e-advantage

SERVICE TIP

R-9976 Hydraulic Compressors

FEBRUARY 2015

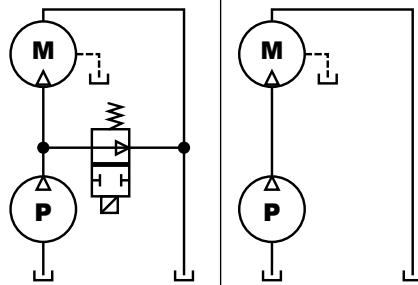
Tim Oliphant, chief project engineer at Red Dot, offers two important spec'ing and installation tips for R-9976-5P, -6P, and -7P compressors:

1. A common installation error is to locate the case drain with a pressure in excess of 72 PSIG. The case drain must be installed with a pressure of

less than 72 PSIG. Any more pressure and you risk blowing the shaft seal.

2. The proper displacement depends on your available hydraulic system pressure, flow rate, and the required compressor capacity for the application. Your Red Dot account manager can provide hydraulic-flow and pressure-curve data to help you make the best choice.

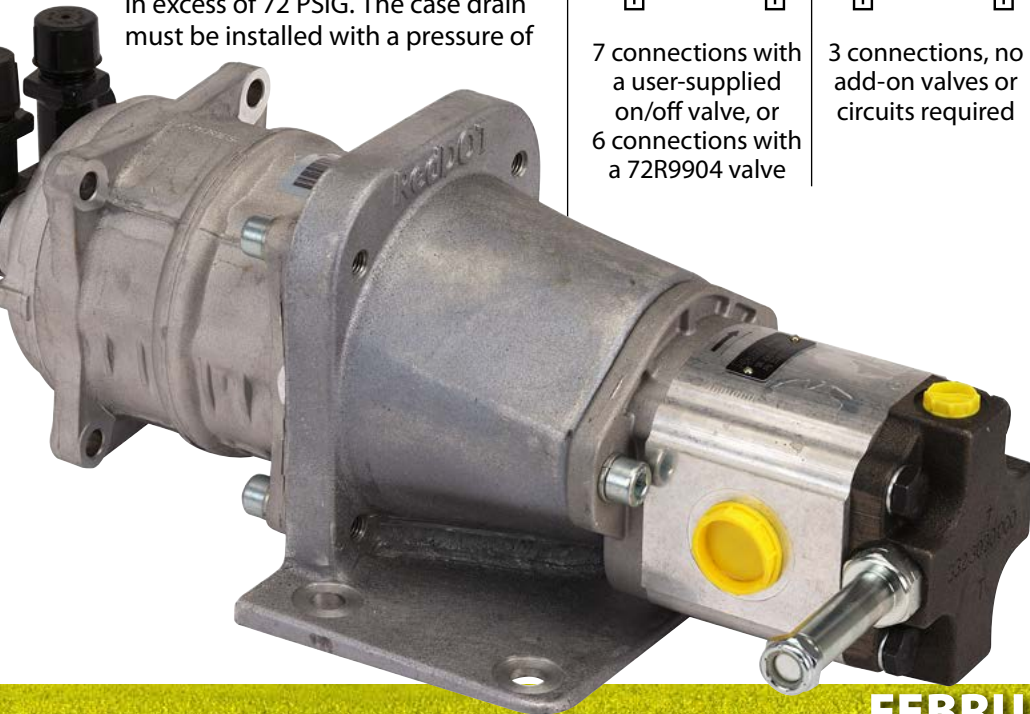
We're replacing the R-9976-3P hydraulic compressor in our catalog with a proven Parker design. It will be available in three displacements:

The new design has a hydraulic motor with an integrated on/off solenoid valve and bypass circuit, which makes installation easier. Other advantages include greater hydraulic flow range flexibility and greater hydraulic pressure range flexibility.

R-9976-3

R-9976-5P,-6P,-7P

7 connections with a user-supplied on/off valve, or 6 connections with a 72R9904 valve

3 connections, no add-on valves or circuits required
